RK8-E Handouts

digital	FIELD SERVICE TECHNICAL MANUAL				Option or Designator
	12 Bit <input checked="" type="checkbox"/>	16 Bit <input checked="" type="checkbox"/>	18 Bit <input type="checkbox"/>	36 Bit <input type="checkbox"/>	RKØ5

Title						RK05 MAINTENANCE MANUAL CORRECTIONS		Tech Tip Number		RK05-TT-3	
All						Processor Applicability		Author J. WALSH/A. MUIR		Rev 0	
8						11		Approval HAROLD LONG		Date	
										Cross Reference

LOWER HEAD
30-10863-01

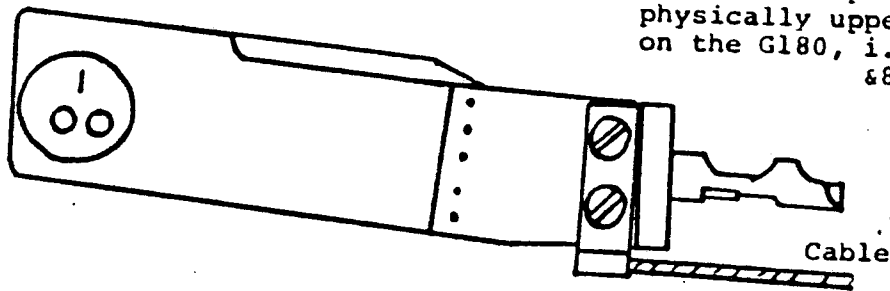
(Cable will plug into the physically upper set of pins on the G180, i.e. pins 5,6,7 & 8)

UPPER HEAD
30-10863-02

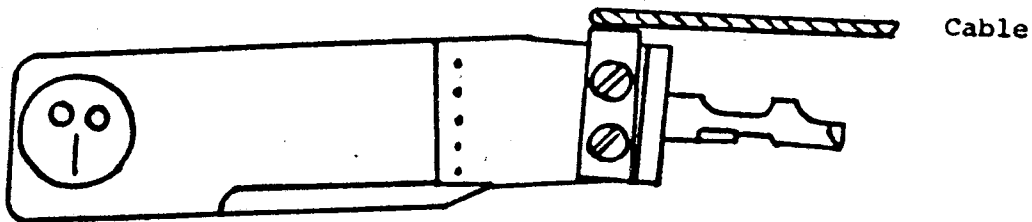
(Cable plugs to pins 1,2,3 & 4 on the G180)

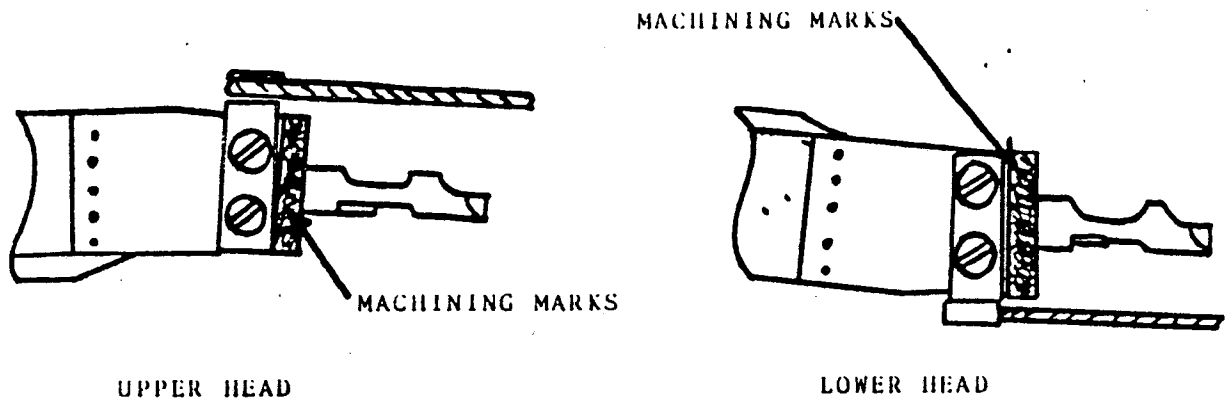
An ECO to the carriage assembly and one to the tailpiece of the R/W heads involved the machining of the flat surface where the head rests on the tang of the carriage. The new REV head will fit in the old REV carriage assemblies. Caution should be exercised however to insure that the pad of the head is on a plane which is parallel to that of the disk surface.

Heads on old REV tailpieces will not fit into new REV carriage assemblies.

New REV tailpieces can be identified by the machining marks on the shoulder. See Figure 1.
